# Access Compliance Report

## Public Rights-of-Way

| Intersection ID: 22230                  | Main Street: N_SARDIS_VIEW_LN | Cross Street: SARDIS_RD                 | Location: NE           |
| ADA ID: 14EAE4F91459                    | Ramp Type: ParaDiag           | Initial Pass/Fail: Fail                 | Overall Compliance: No |

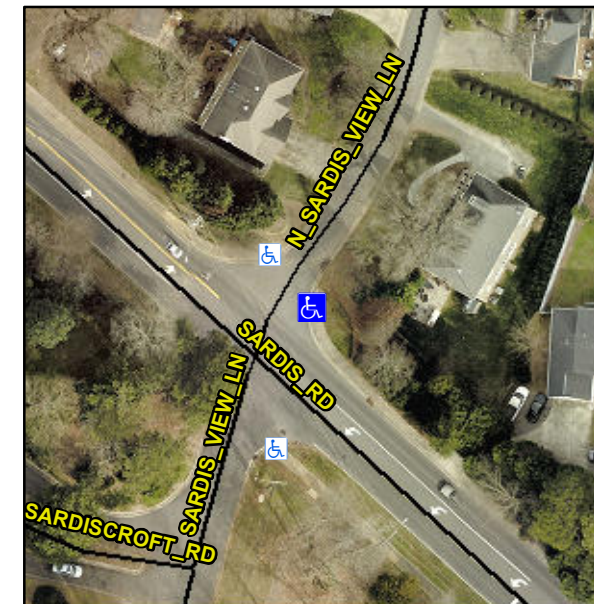
Surveyor Notes:

**LT RP < 5%**

PROW/ADA:

**R304.5.3, R304.3.2**

Possible Solutions:

**Remove & Replace Curb Ramp With Two New Directional Ramps or Equivalent.**
